**MONTGOMERY COUNTY HISTORIC PRESERVATION COMMISSION**  
**STAFF REPORT**

<b>Address:</b>	8017 Hampden Lane., Bethesda	<b>Meeting Date:</b>	3/25/2020
<b>Resource:</b>	Contributing Resource <b>Greenwich Forest Historic District</b>	<b>Report Date:</b>	3/18/2020
<b>Applicant:</b>	Mark and Marjorie Kramer Mark Kramer, Architect	<b>Public Notice:</b>	3/11/2020
<b>Review:</b>	HAWP	<b>Tax Credit:</b>	n/a
<b>Case Number:</b>	35/165-20B	<b>Staff:</b>	Dan Bruechert
<b>PROPOSAL:</b>	Entrance Removal, Rear Addition, Tree Removal

PROPOSED FRONT ELEVATION  
SCALE: 1/4"=1'-0"

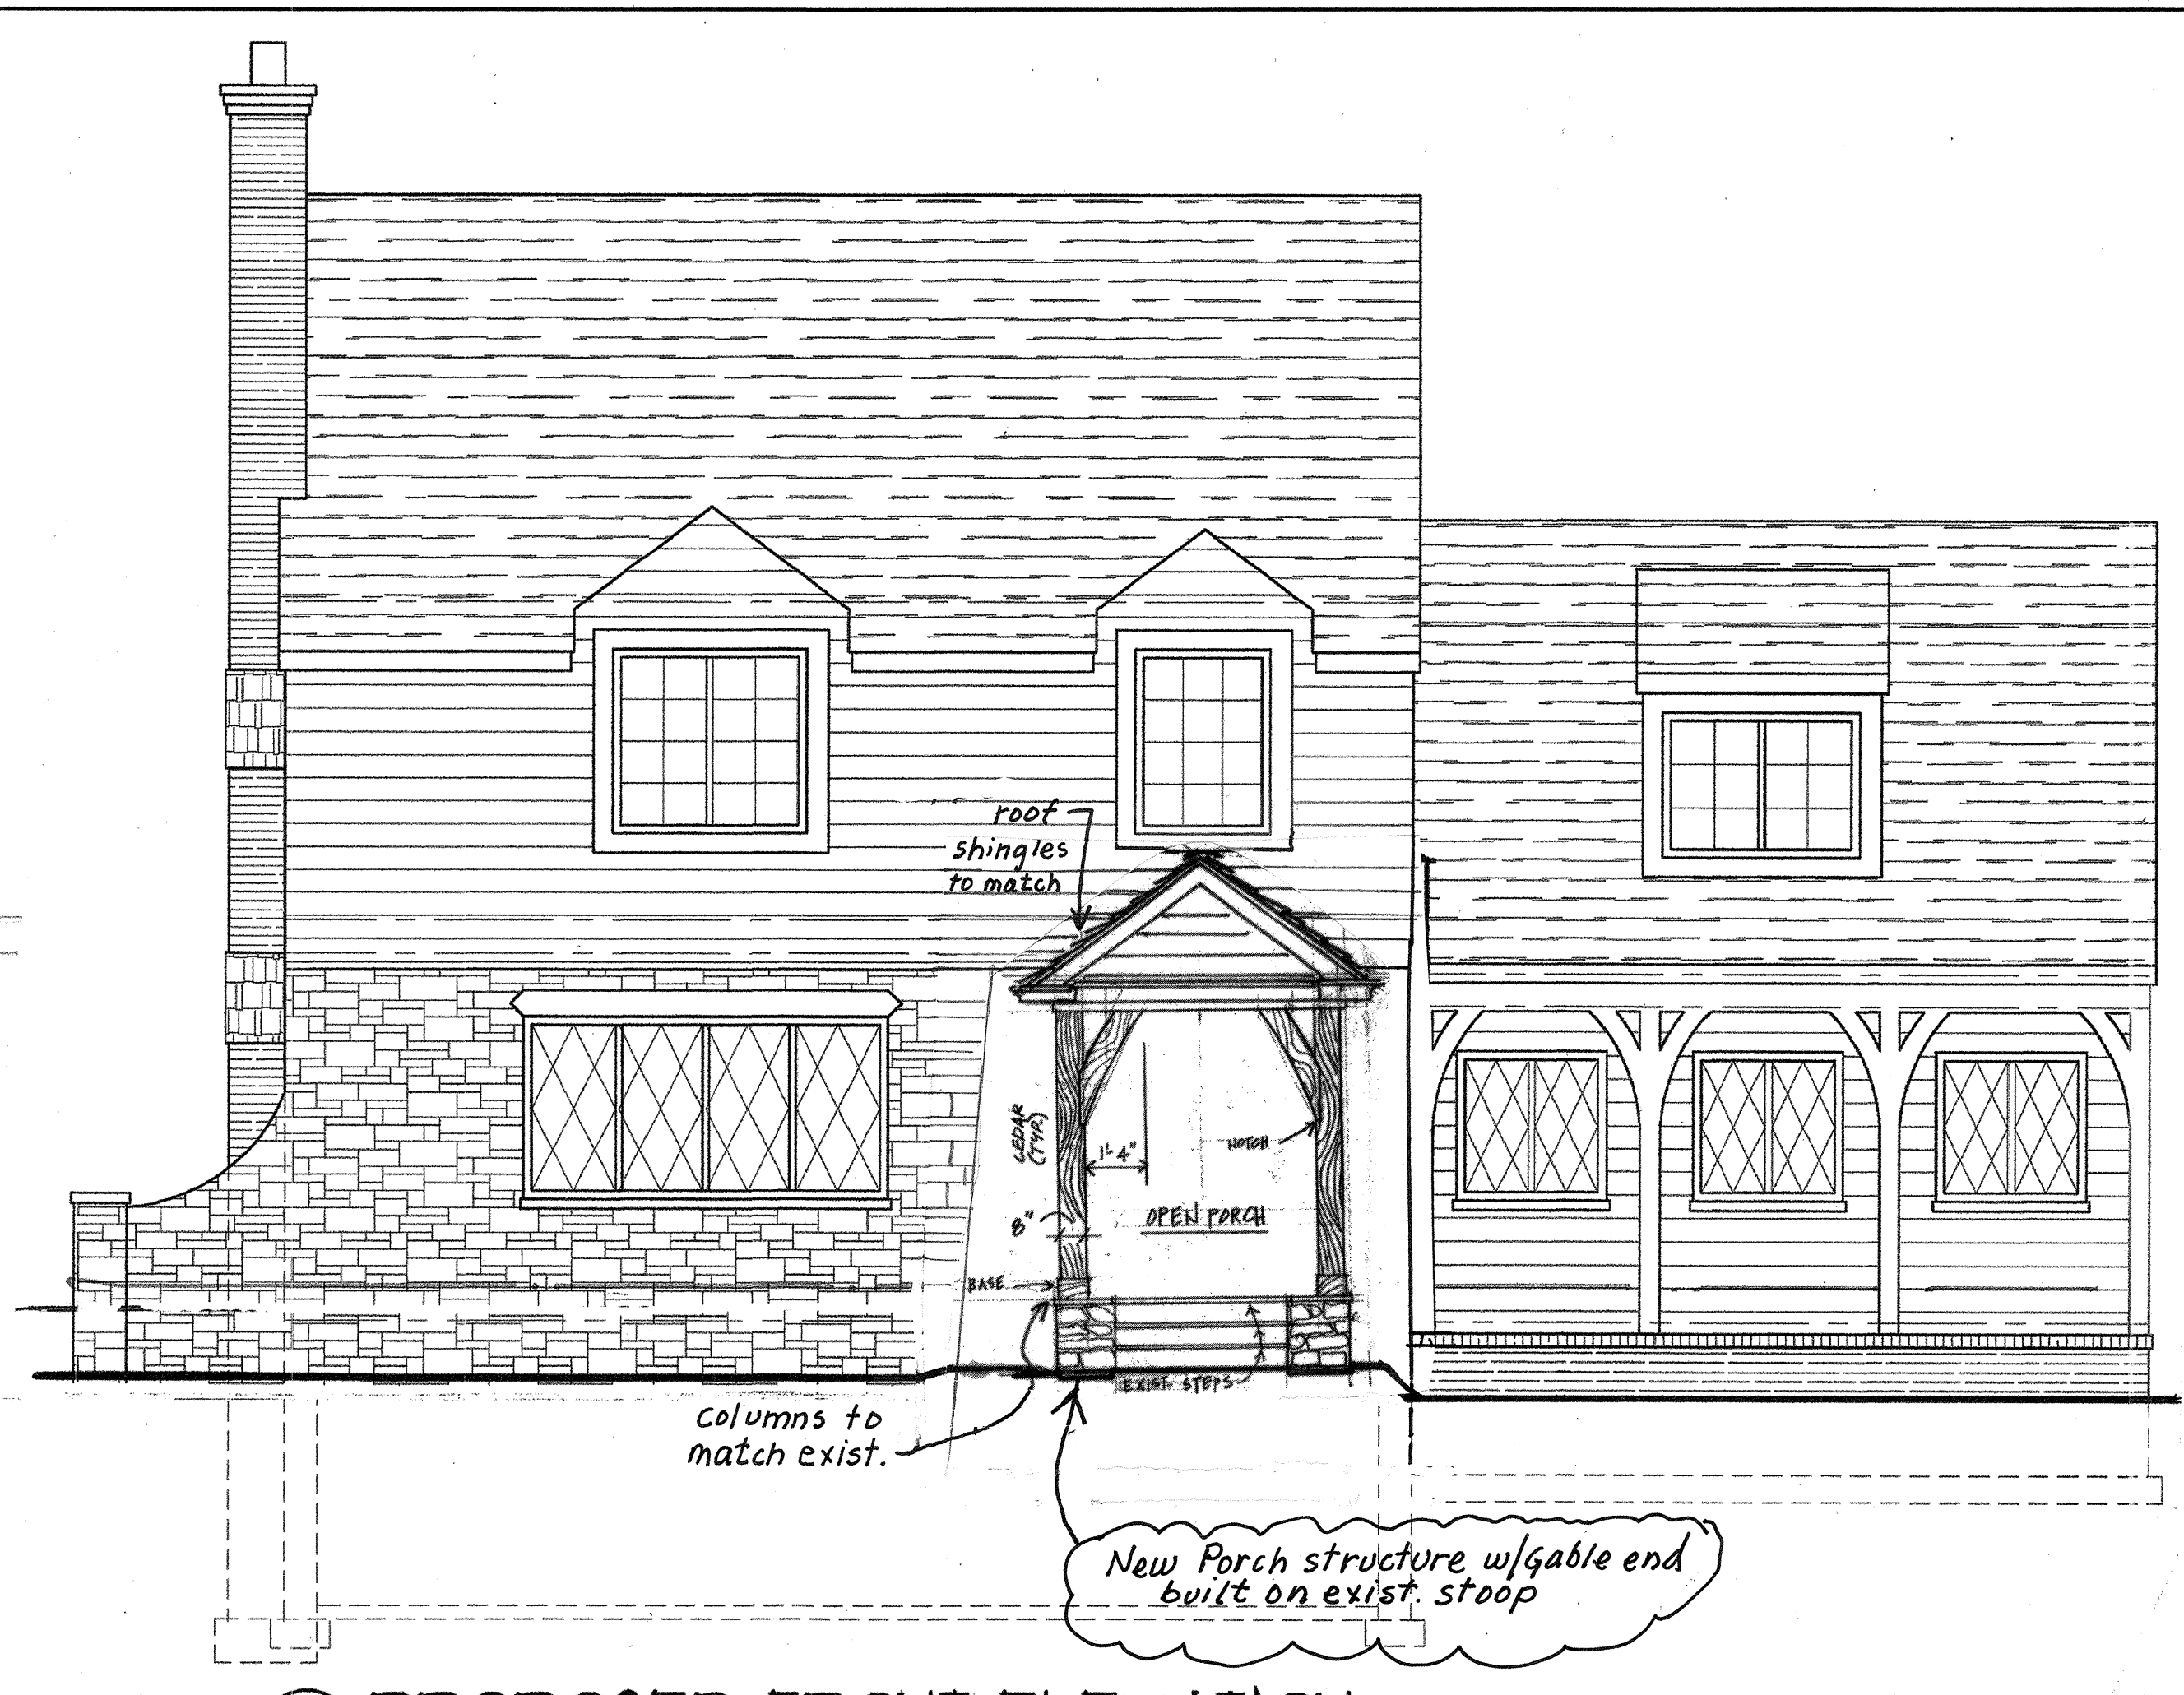
The historic front entry has a standing seam copper roof supported by wrought copper brackets. The applicant proposes removing this entrance and installing a new porch with a gable roof porch, supported by wood posts and brackets - copying the design and dimensions from the front elevation of the garage. The post and brackets motif is found throughout the historic district.

The *Design Guidelines* state that alterations to porches visible from the right-of-way are to be reviewed under strict scrutiny. Strict scrutiny as defined in the *Design Guidelines* focuses on preserving the integrity of significant architectural features. The *Guidelines* also allow for the addition of front porches that are compatible with the historic character of the house.

At the preliminary consultation, the HPC was virtually uniform in finding that the existing porch covering could be removed without negatively impacting the character of the historic building or surrounding district. Staff concurs with this assessment and recommends that the HPC approve the removal of the existing copper porch covering.

In place of the existing covering, the applicant proposes to install a new front-gable porch supported by wood posts with brackets. The gable roof will be covered in shingle that matches the historic house. The footprint of the porch will not be altered.

Staff finds that the front gable is a more compatible form than the previously proposed shed roof. The front gable slope will match the slope in the larger, 2<sup>nd</sup>-floor gable above the paired windows. Staff additionally

finds the proposed materials (wood, architectural shingle, and siding) are all compatible with materials found throughout the house. Staff supports the approval of the proposed porch.
